November 19, 2024

RE: Addendum to Hydrogeological Report for the Neches and Trinity Valleys GCD
Middle Wilcox Wellfield – Redtown Ranch Property, Anderson County, TX

RE: Hydrogeological Report for the Neches and Trinity Valleys GCD
Middle Wilcox Wellfield – Redtown Ranch Property, Anderson County, TX

Figure 1. Analytical modeled cumulative 50-year drawdown in the Middle Wilcox Aquifer

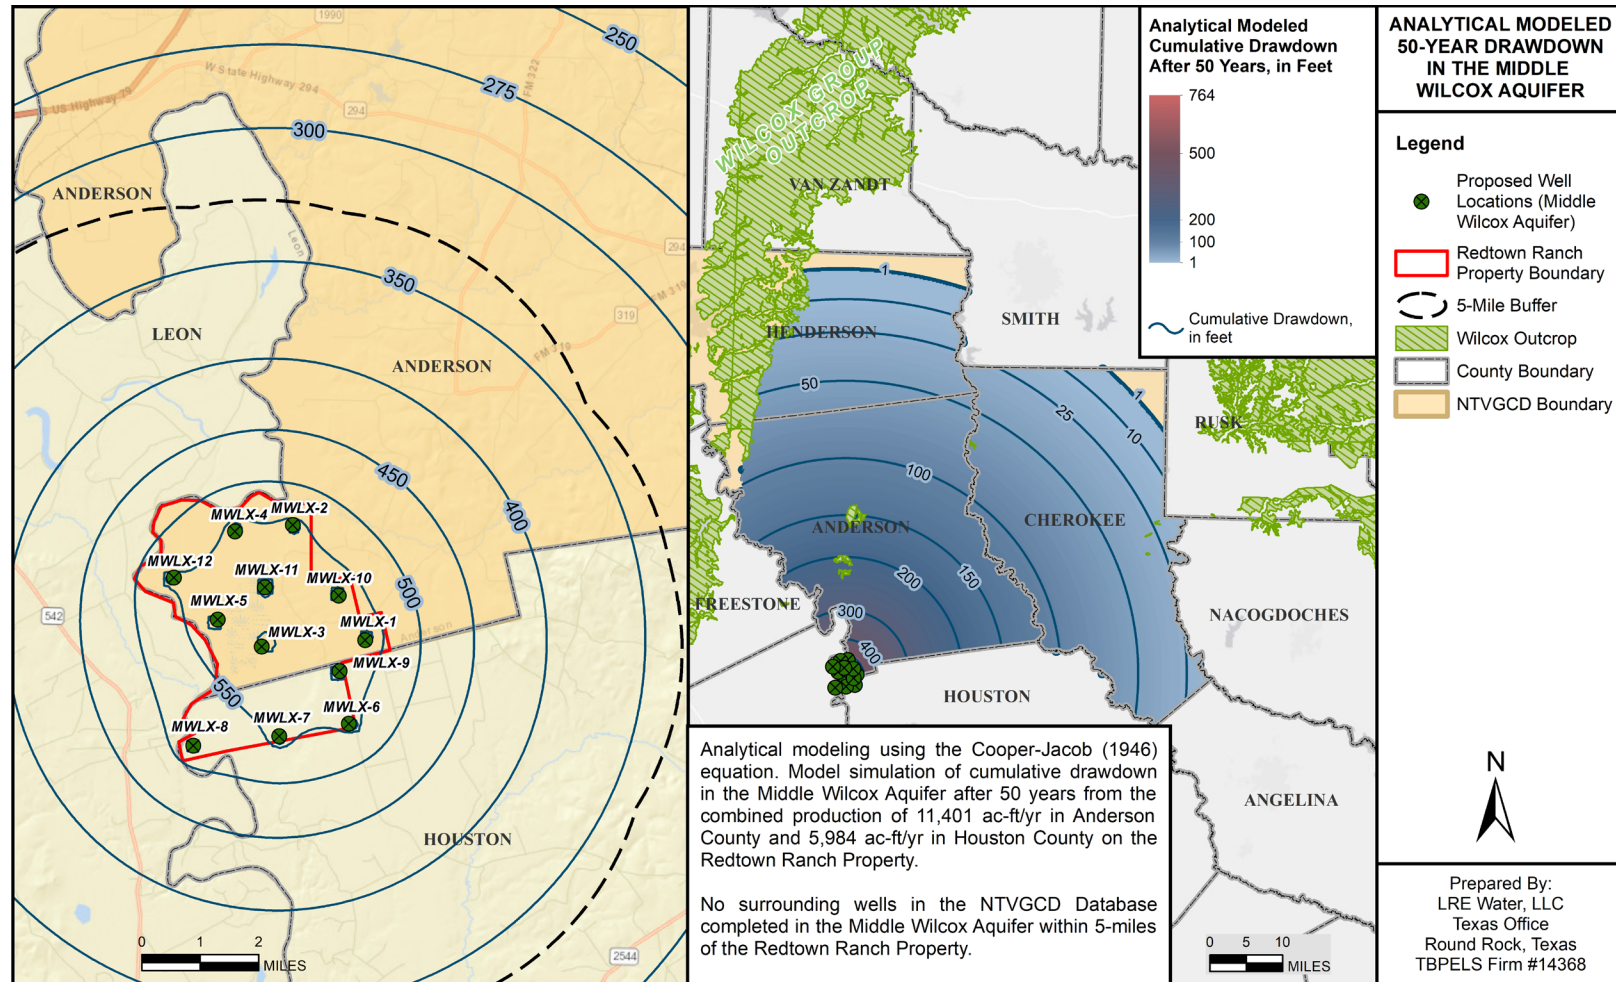
While the decisions about the completeness of the report will be up to our groundwater hydrologist, there are several things that I would like to see included, such as illustrations or maps showing the cone of depression depicting the contours for impacts for all of the wells listed in Appendix B in the LRE Water Report of September 5, 2024 for the well fields. The hydrologist has indicated that I will receive a response from him on this, this week.

Cumulative drawdown in each proposed well was calculated by superposition of drawdown effects and is equal to the sum of the individual drawdowns caused by each pumping well. The cumulative drawdown in the proposed wells after five years is presented in Table 3. A drawdown contour map after five years of pumping is provided in the Hydrogeologic Report (Appendix B). Cumulative drawdown in the proposed wells after 50 years of pumping is presented in Table 4. Illustrations showing the cone of depression depicting the contours for impacts for all wells listed in Appendix B of the LRE Report (Appendix B) after 50 years of pumping is presented in Figure 1 (as requested by Mr. John Stover – See Appendix A).

Figure 2. Numerically modeled marginal drawdown in the Middle Wilcox Aquifer (Layer 8) from "Proposed MWLX" after 5 years (2025-2030)

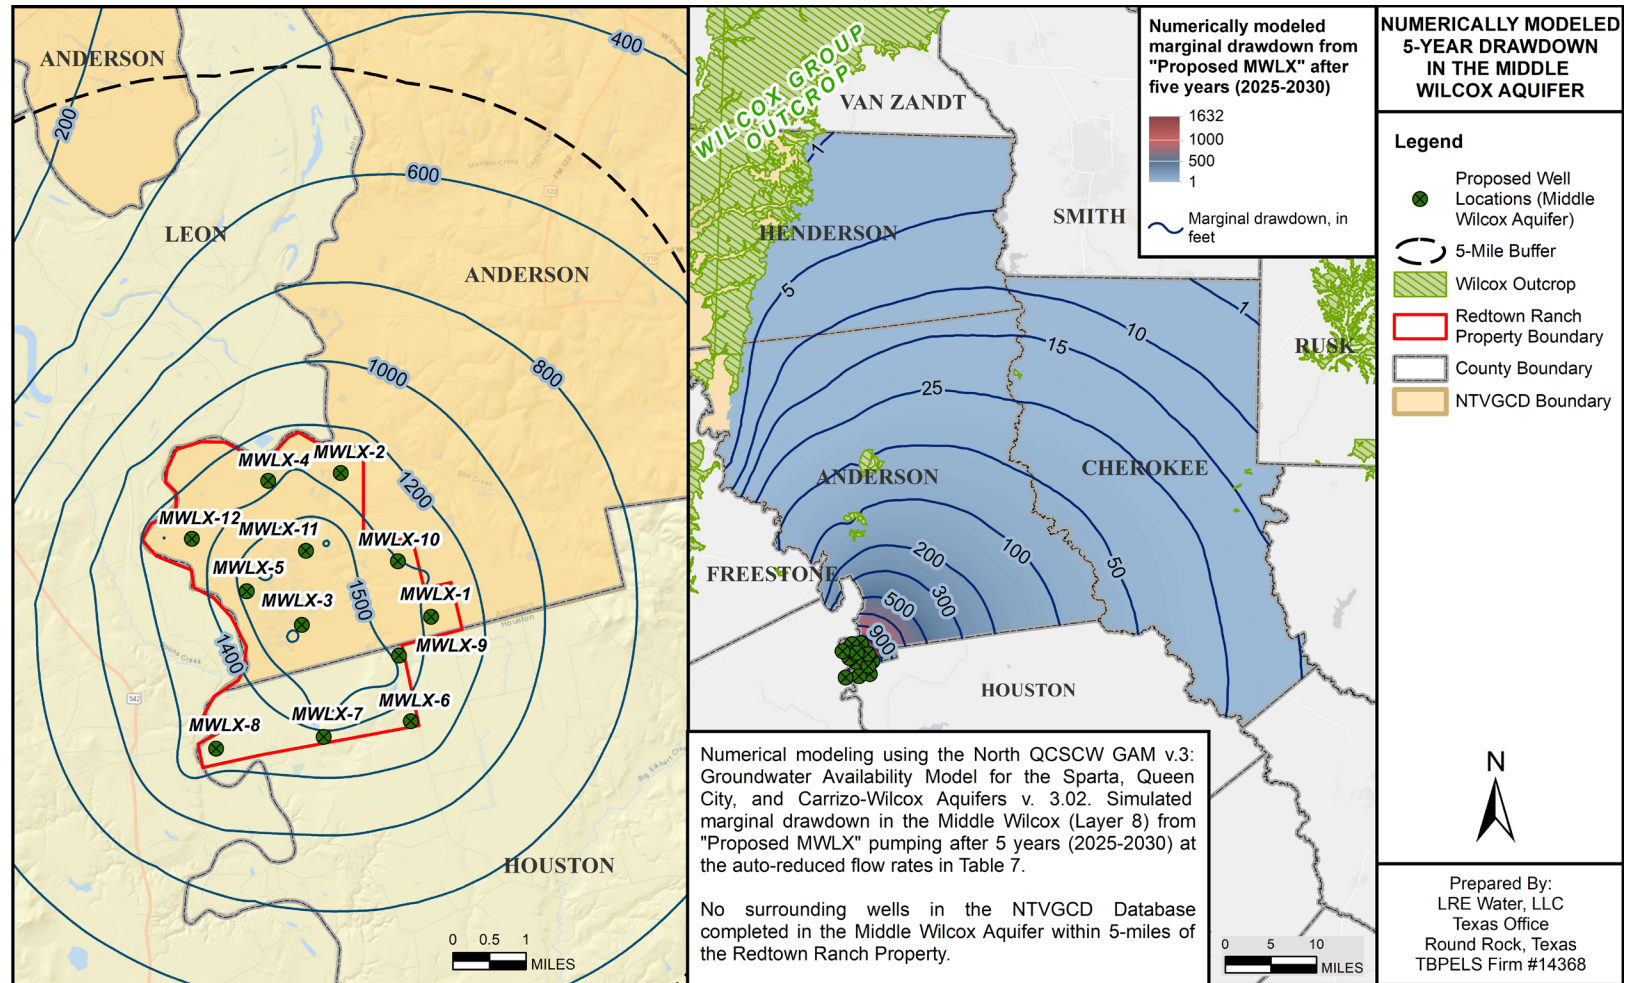
LRE compares the water level decline after 5 years from the project to the DFC drawdown noted in the tables as "Simulated "Base Run" Scenario 33 (TM 21-01)". The DFC drawdown noted in the comparisons is the simulated water level decline in 2080. We request that LRE provide a comparison with the simulated water level decline from the project in 2080.

- Drawdown from the “Proposed MWLX” after five years from 2025 to 2030 (Figure 2)
- Drawdown from the “Proposed MWLX” after 50 years from 2025 to 2075 (Figure 3)
- Residual drawdown (recovery) five years after “Proposed MWLX” stopped from 2075-2080 (Figure 4).

Figure 3. Numerically modeled marginal drawdown in the Middle Wilcox Aquifer (Layer 8) from "Proposed MWLX" after 50 years (2025-2075)

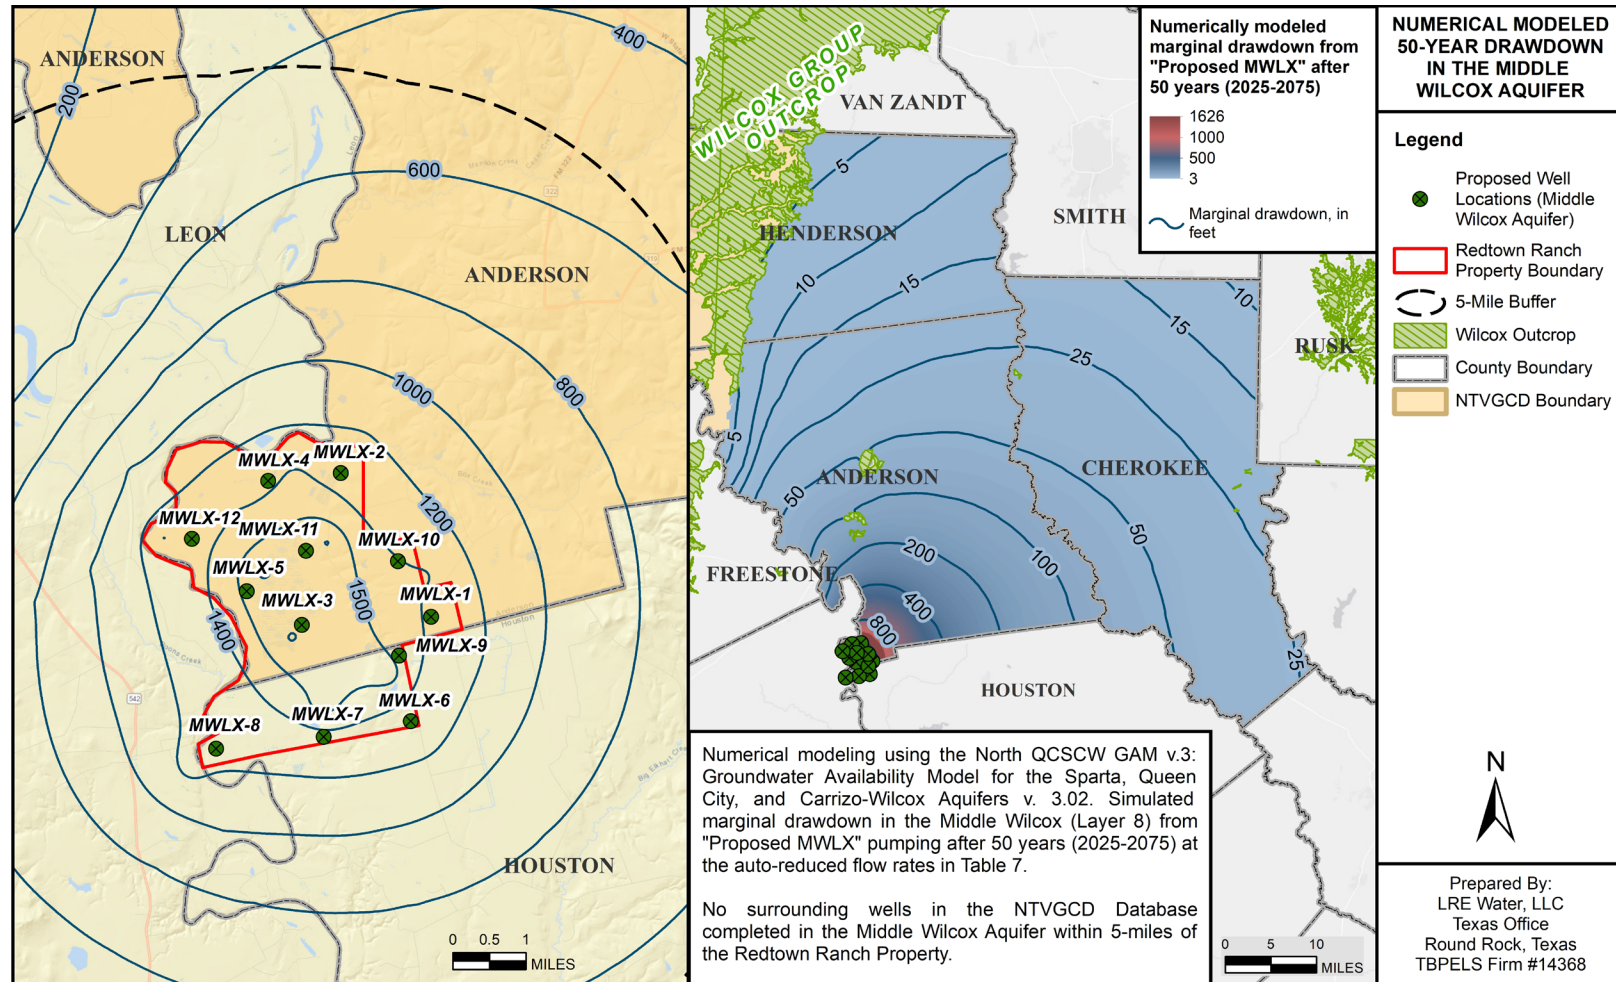
1. Yes, the 2025-2075 is fine for the 50-year run.
2. Yes, repeating the 2080 stress period is fine. Please show recovery results after 5 years (2080) also.
3. If the auto-flow reduction is required for convergence, that is fine. I obviously cannot speak to how the District will receive changes to the model or other approaches for estimating impacts, but I am open to considering your technical approaches to addressing model limitations.

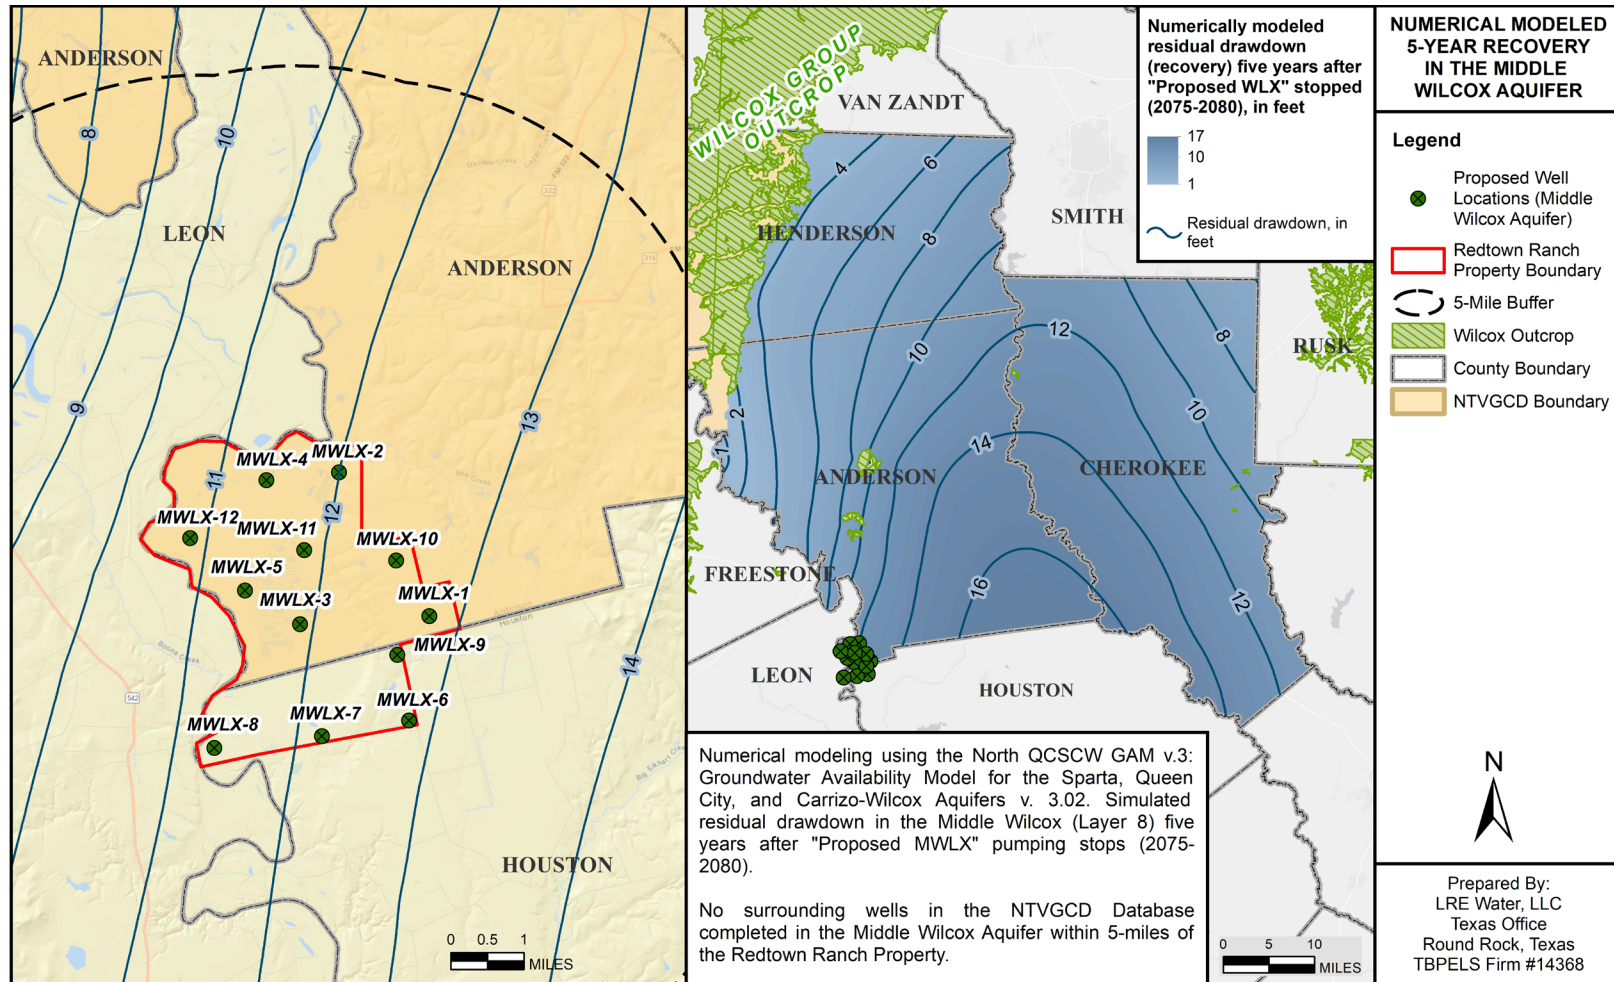
For the numerical modeling using the TWDB GAM, the recovery time was not documented in the hydrogeologic reports. We ask that LRE document the recovery time using the TWDB GAM.

Please model 5 years of recovery with the existing model out to 2080.
